Transmittal

RE **Willamette Water Supply System Water Treatment Plant (WTP)**
Land Use Application Supplemental Submittal

Subject: Design Modification Request for Orr Drive Section

SITE GRADING
ROADWAY TYPICAL SECTIONS 1

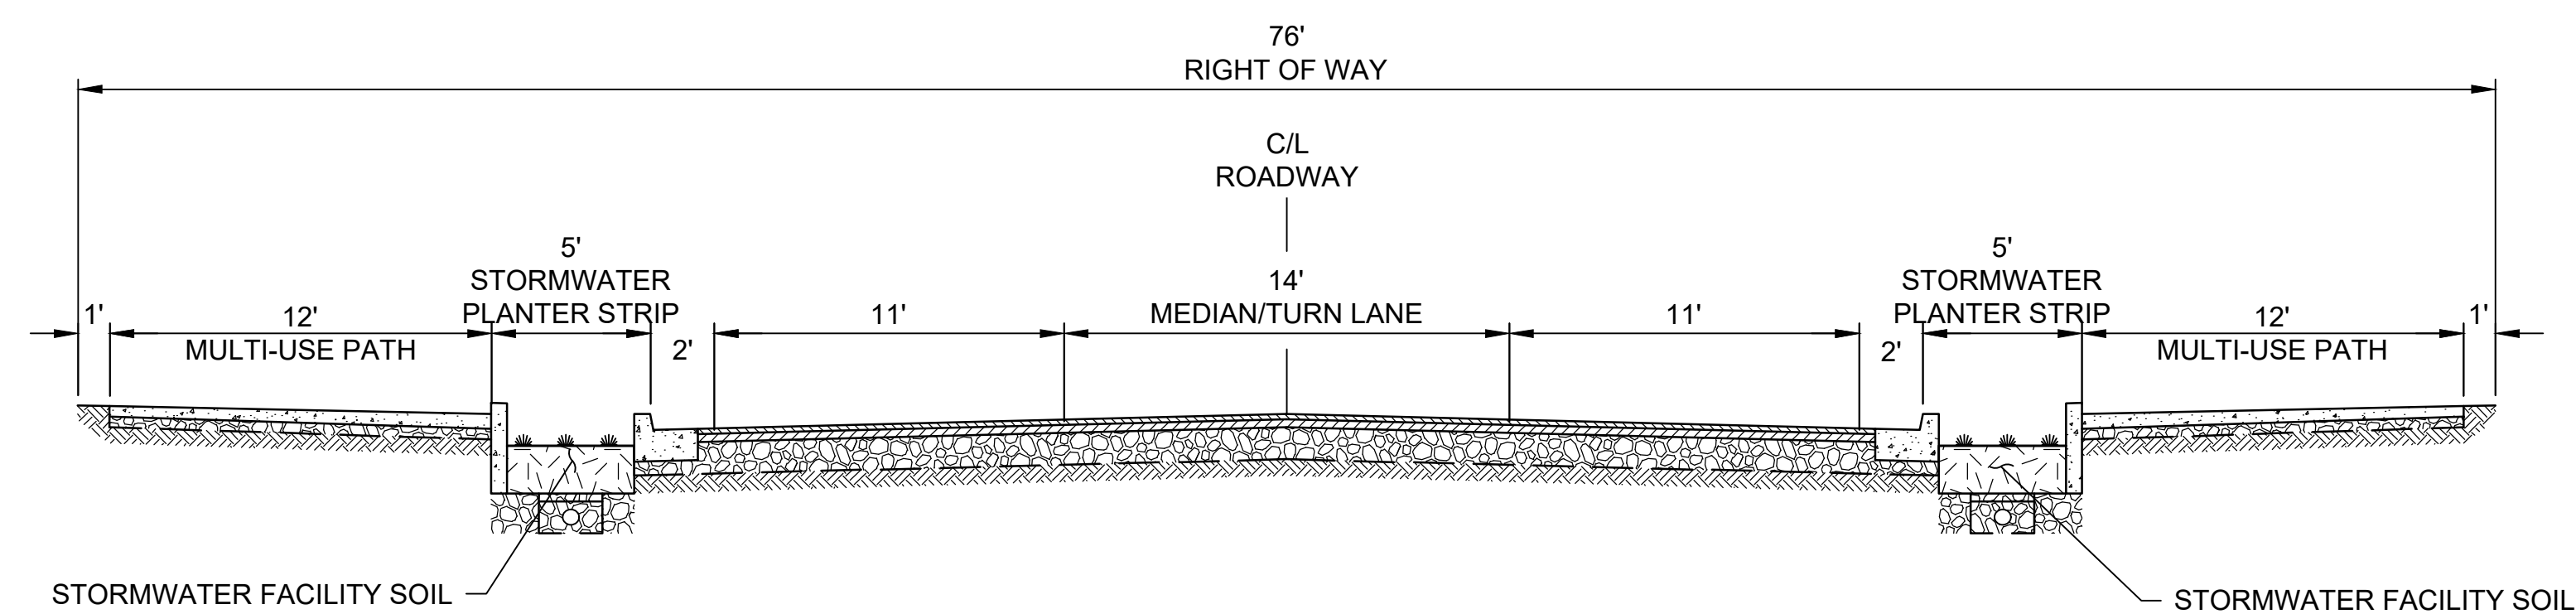
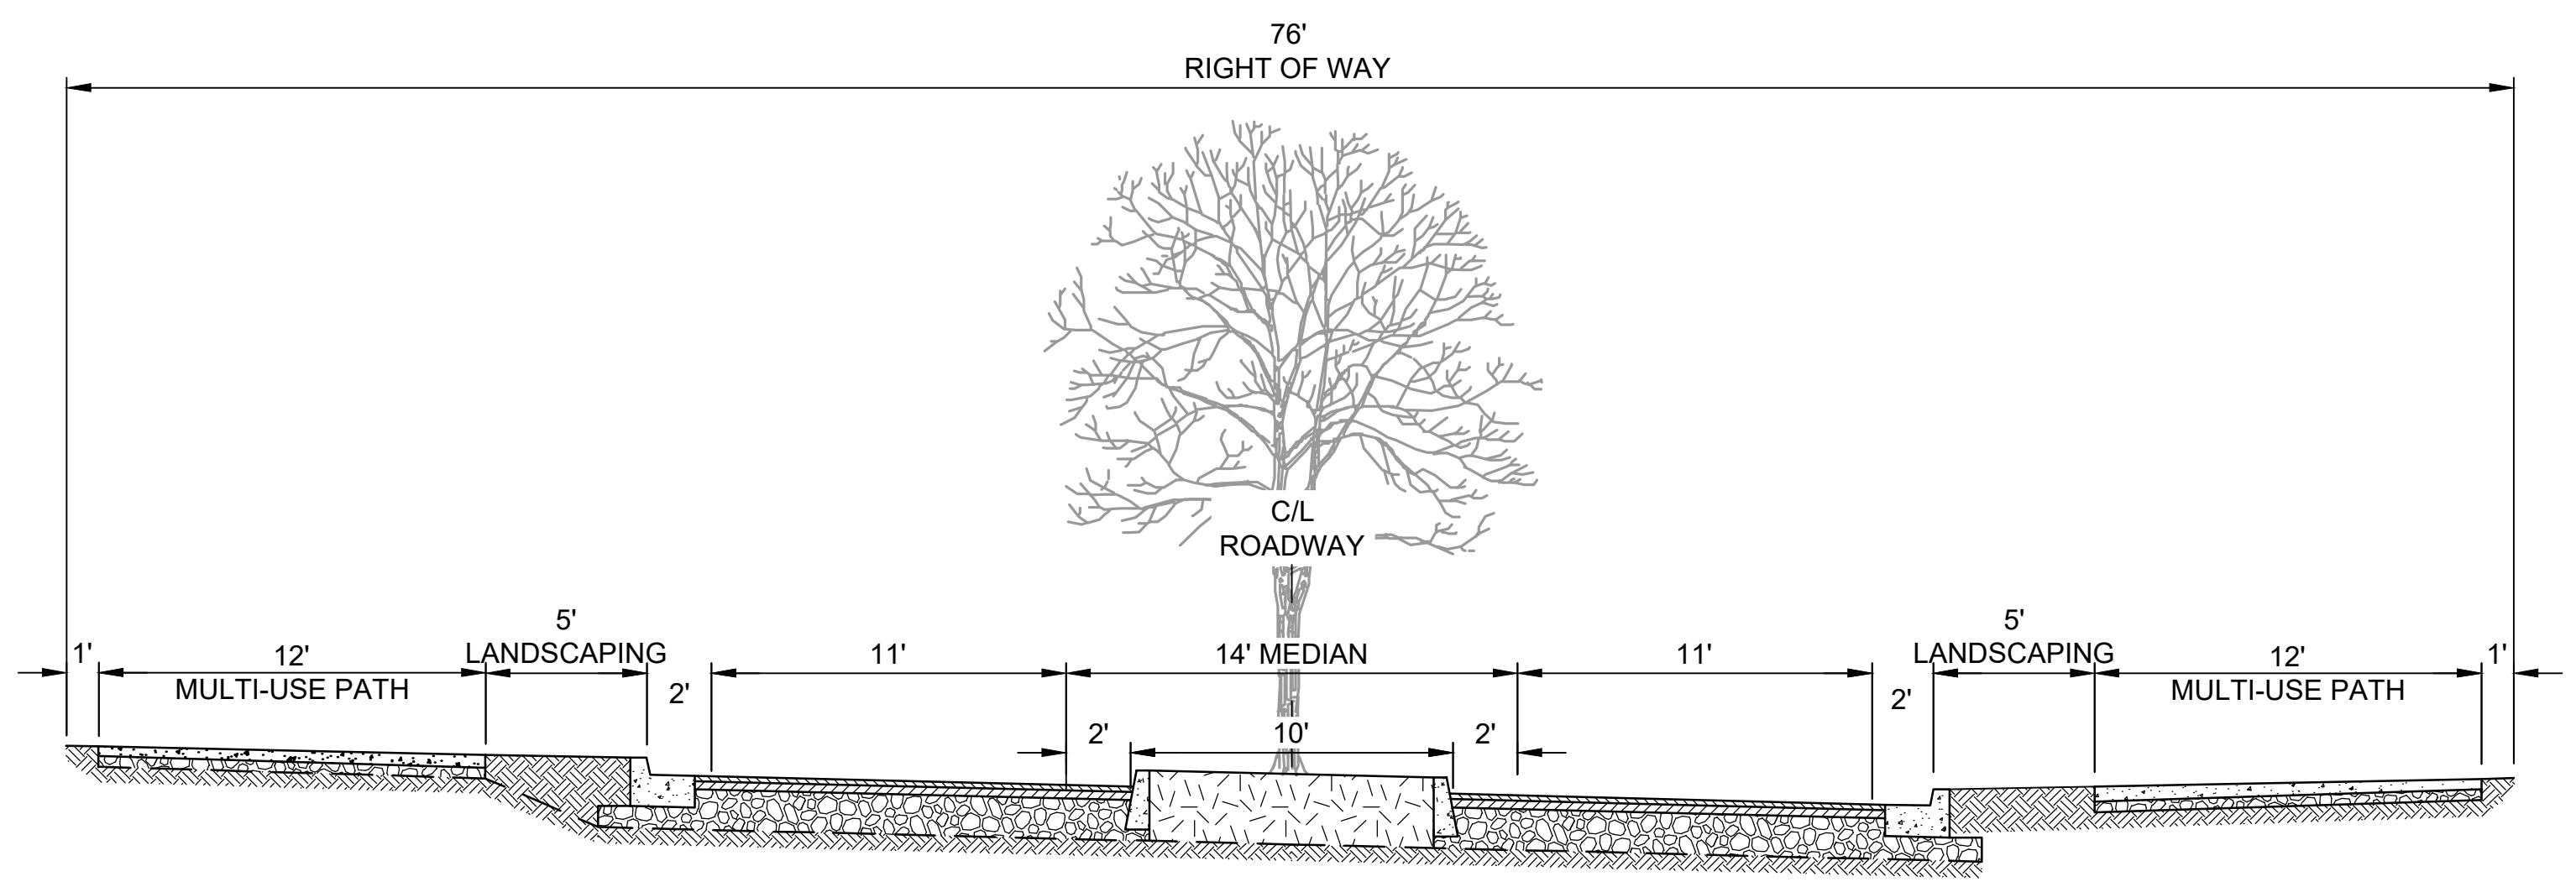
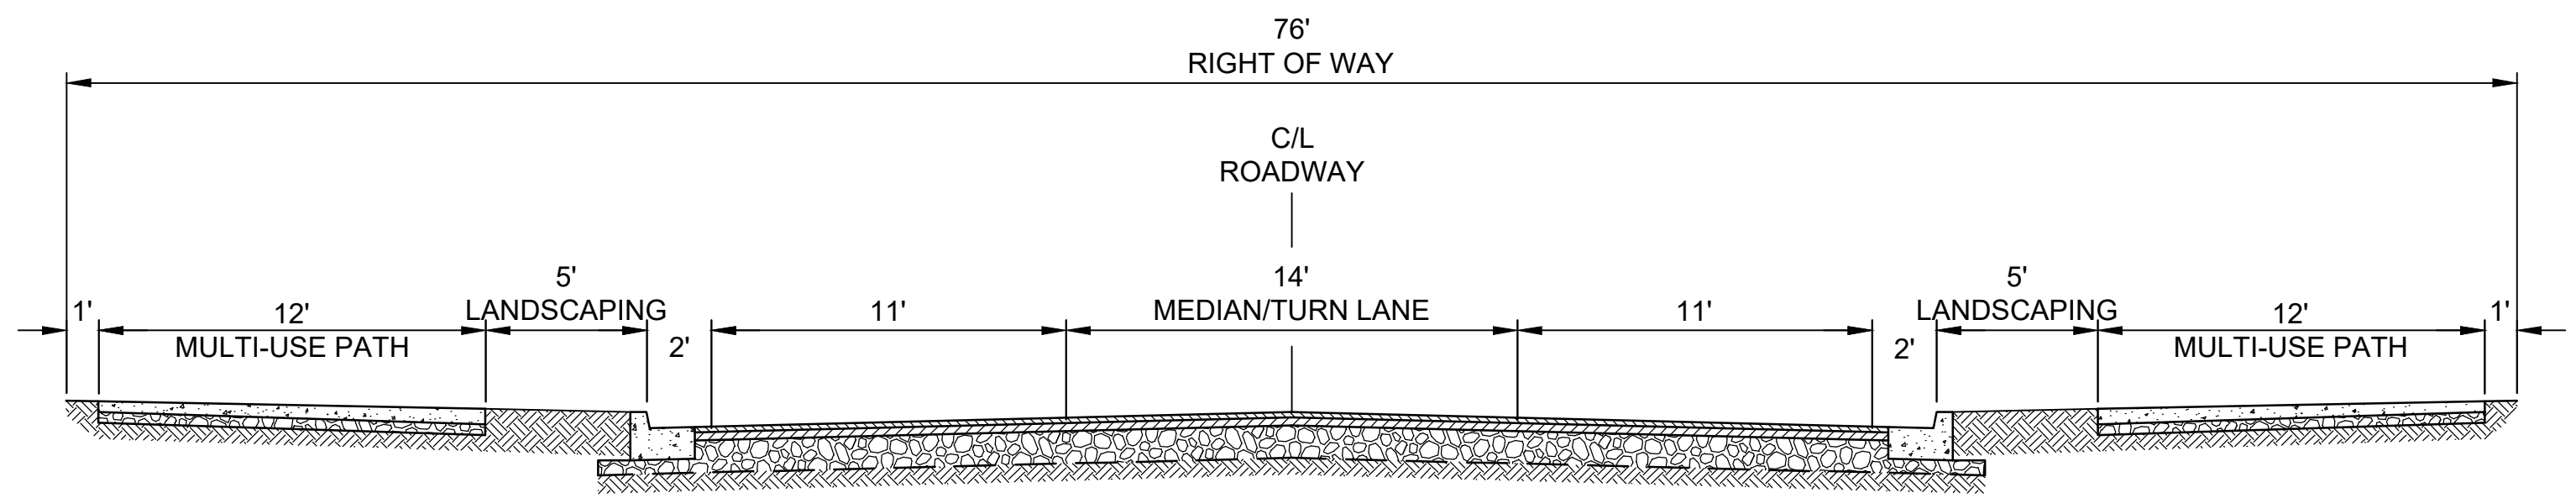
The following revised road section for SW Orr Drive is requested.

In summary, a 13' wide vehicle lane and 12' wide multi-use path is requested in place of an 11' wide vehicle lane, 6' bike lane, and 8' wide sidewalk.

Median / turn lane	7' wide (half of median / turn lane)
Vehicle lane	13' wide (11' wide vehicle lane with 2' shy distance)
Landscape strip	5' wide
Multi-use path	12' wide
Space behind sidewalk	1' wide
Half-street right-of-way	38' wide (76' total road right-of-way width)

TYPICAL SECTION 1
SW 124TH AVENUE - HALF-STREET IMPROVEMENTS
 SOUTH OF ORR ROAD AND NORTH OF EXISTING RETAINING WALL
 (LOOKING SOUTH)

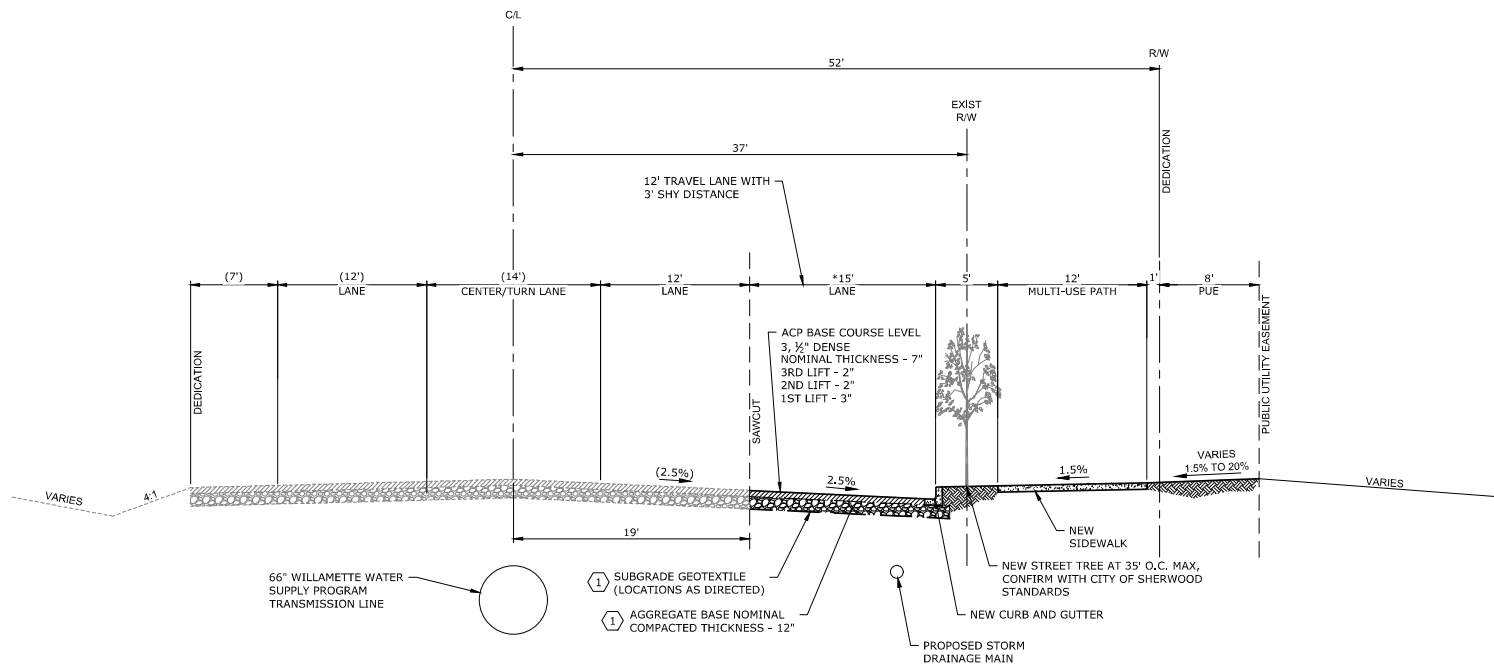
The following modifications to the frontage improvements along 124th Avenue are requested.

The following modifications to the frontage improvements along 124th Avenue are requested in the area adjacent to the existing retaining wall if the County acquires the property between the WTP property and the 52-foot right-of-way dedication by December 31, 2020, in which case the applicant will provide half-street improvements on this frontage:
